Kildare County Council
Request for additional
information

RE: Planning Permission is sought for development at site at Drummin Td., Carbury, Co. Kildare, the development will consist of the following: Demolish part of their existing facility and to develop a new facility for the indoor production of phase 1, 2 and 3 mushroom substrate, currently being produced outdoors on the site, as detailed hereunder: a Demolish only those existing growing tunnels required to make way for proposed development and demolish existing outdoor phase 1 composting facility, b Construct a new building to facilitate the indoor production of phase 1 mushroom substrate, comprising of 1. A double portal framed structure fully enclosing the raw material storage and handling area for the phase 1 composting process and 2. An adjoining mass concrete walled, flat roofed structure enclosing sealed phase 1 composting bunkers with 3. Covered conveyor belts and ancillary plant on flat roof area together with 4. Ventilation stack to flat roof area all as part of a single building. C Construct a new building to facilitate the production of phase 2 and phase 3 mushroom substrate, comprising of a double portal framed s

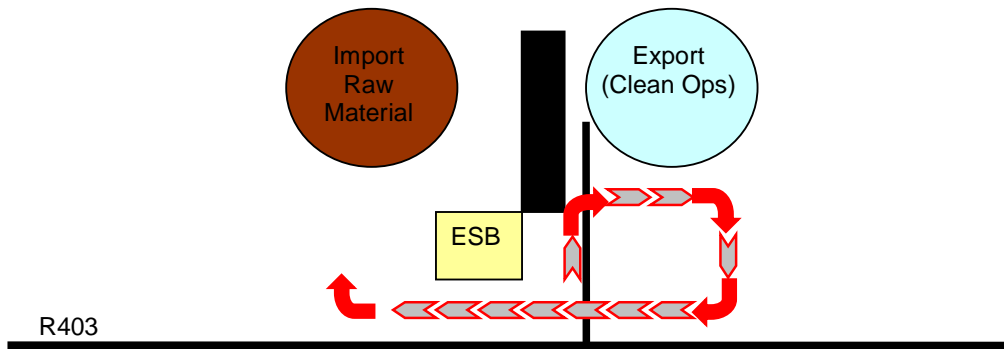
“Applicant is requested to consider further reducing the number of entrances to the development to just one, the current proposal shows the two proposed new entrances too close together”.

There is a large ESB substation located on the site between the two proposed accesses. The rationale guiding the decision to propose two access points was that the substation prevents left turns into the site from the southern access and conversely right turns into the site from the northern proposed access, accordingly neither access in isolation is considered wholly satisfactory in serving the development. The optimum solution with respect to serving the site and minimising potential conflict and delay on the R403 is the proposed dual access arrangement.

If a single access is provided at the site it will need to be provided on one side or other of the electricity substation accordingly not all movements will be achievable upon entry. The diagram below shows that required route of a vehicle importing raw materials should the access be located to the south of the substation. Clearly the converse arrangement with an access to the north of the substation would require export vehicle to undertake a similar, yet mirrored route to that shown in the diagram. Given the limitations imposed by the present infrastructure it can be seen that a singular access arrangement would unnecessarily complicate internal manoeuvres which in turn will conflict with vehicles entering the site. With the single access there is the potential that entering vehicles and finding internal vehicles blocking their path, might from time to time be forced to wait in the carriageway of the R403 outside the site. Such vehicular conflict and the associated potential difficulties on the R403 are clearly undesirable.

Job Title:	PROPOSED NEW PHASE 1, 2 + 3 COMPOSTING FACILITY		
	CARBURY COMPOST Ltd.		
	DRUMMN Td, KILDARE.		
Dwg. No:	3154CPL-06-205	Rev. No:	A
	Bunker Building - Elevations

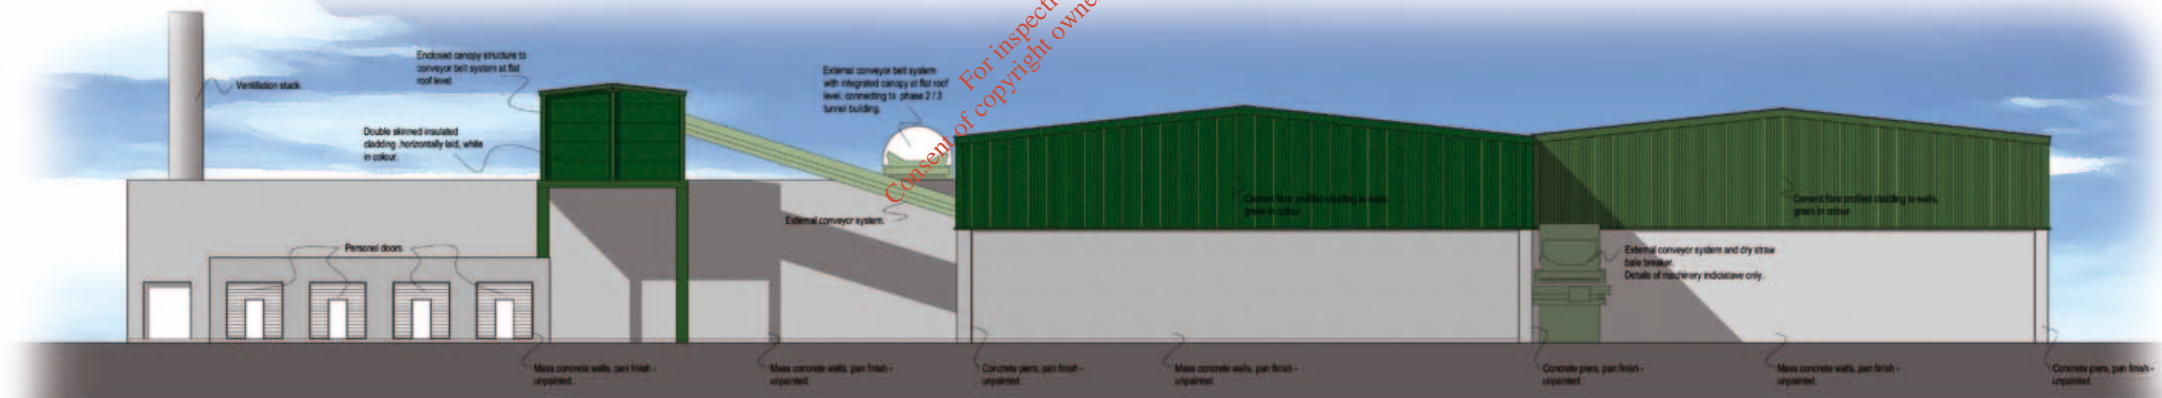
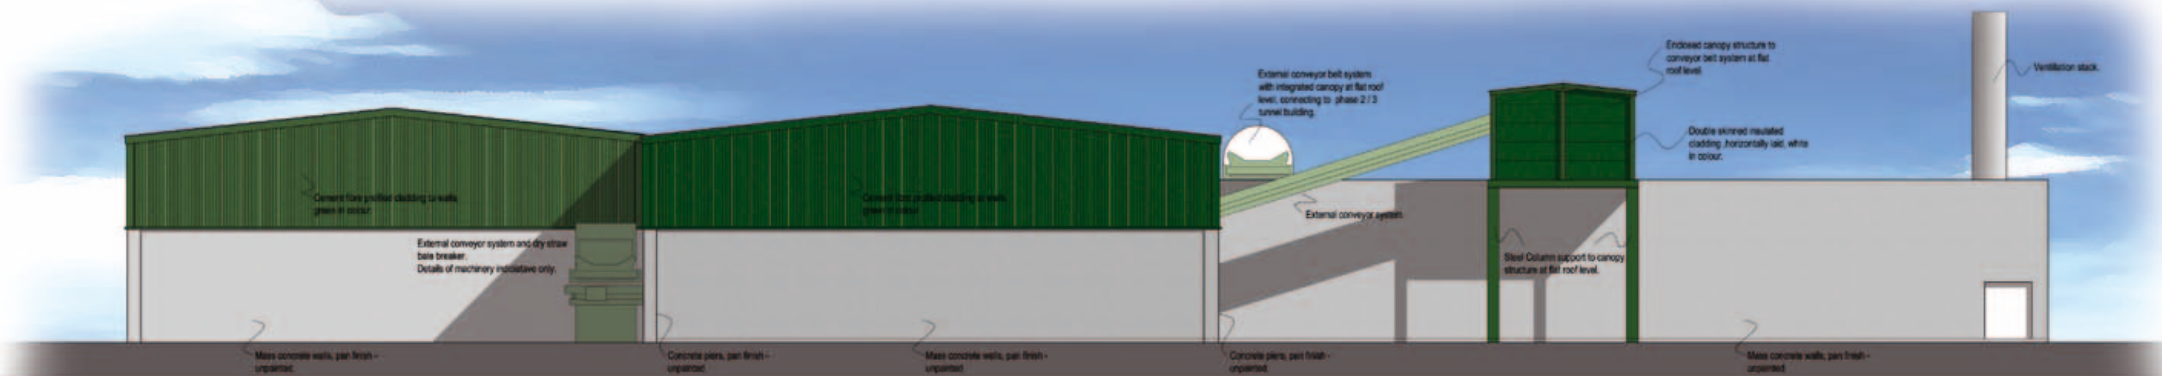
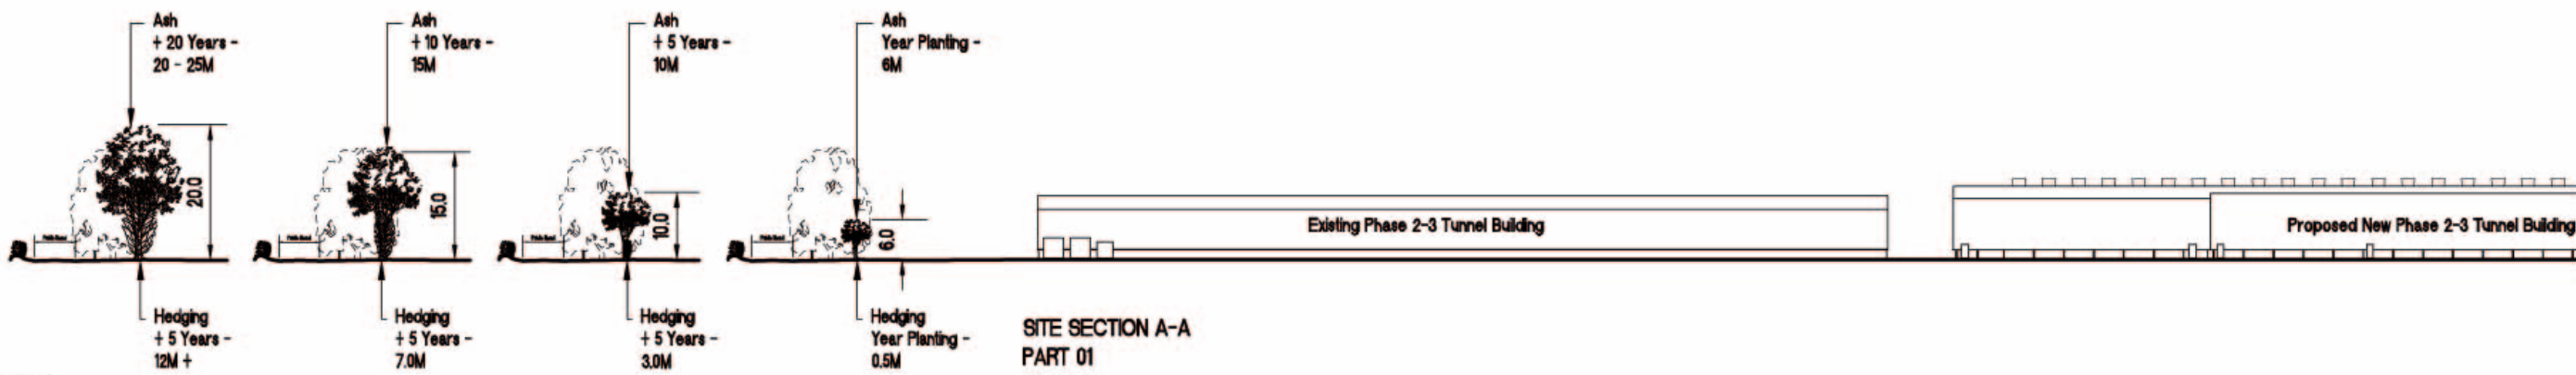
- Cross sections shall also be required, demonstrating the relationship of adjacent dwellings and public roads to the proposed development.
 - Please submit a full set of coloured elevational drawings, at a suitable scale, indicating in detail the proposed external finishes and colour. The chosen material finish shall reflect the proportions and detailing of the whole building, which shall break down the bulk of the proposed structures. The chosen colour scheme shall ensure the proposed development is visually unobtrusive and set into the rural landscape.

Revisions:
A - 25/08/13: Main level glazing omitted, cladding colour revised to green as requested by Kildare Co. Council in clarification of further information. Section of conveyor canopy structure reduced in height. B1

Scale: 1: 500	Date: 05-05-2016	Job Title: PROPOSED NEW PHASE 1 2 + 3 COMPOSTING FACILITY CARBURY COMPOST Ltd. DRUMMIN Td, KILDARE.
Designed by: CARBURY COMPOST Ltd.	Checked:	Drp. No: 3154CPL-06-198 Site Sections
Drawn by: B. THORNTON	Rev. No: A

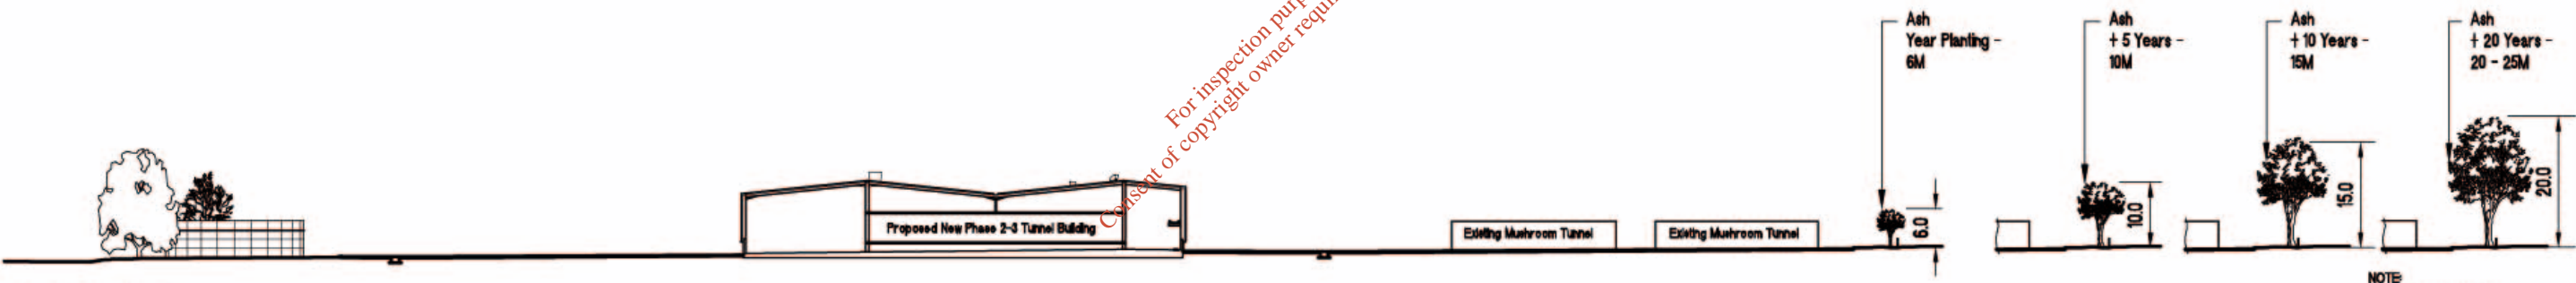
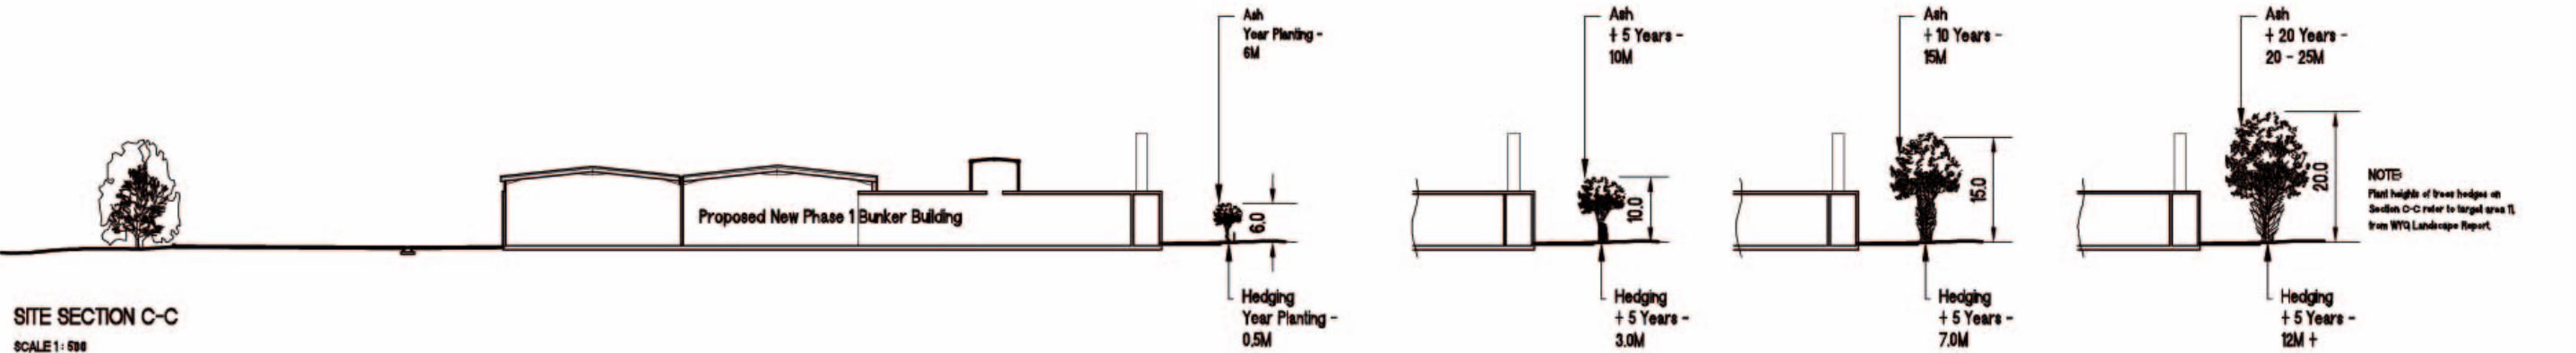
- Details of existing mature hedgerow & trees to be maintained, reinforced or removed on site.
- The names of species in both Latin and English and a schedule for implementation for the proposal. Species shall be predominantly native, deciduous, indigenous to the area, and should incorporate the use of mature and semi-mature tree species.
- Cross sections of the sites boundaries showing the heights of proposed screening at time of planting and at different growth periods to maturity.

NOTE:
Plant heights of trees/hedges on Section A-A refer to target area 01 - 04, from WYQ Landscape Report.
It should be noted that all mature trees to western boundary, of public road, not required to be removed as part of the development will be retained and reinforced with hedging as per WYQ recommendations.

NOTE:
Plant heights of trees/hedges on Section B-B refer to target area 04, from WYQ Landscape Report.

NOTE:
Plant heights of trees/hedges on Section C-C refer to target area 11, from WYQ Landscape Report.

Revisions:
A: 20-09-2016, Revise to show plant heights at various stages of maturity, as recommended by WYQ. Created by: [Name], Checked by: [Name].
Copyright © CS Pringle Ltd. Unauthorized reproduction prohibited.
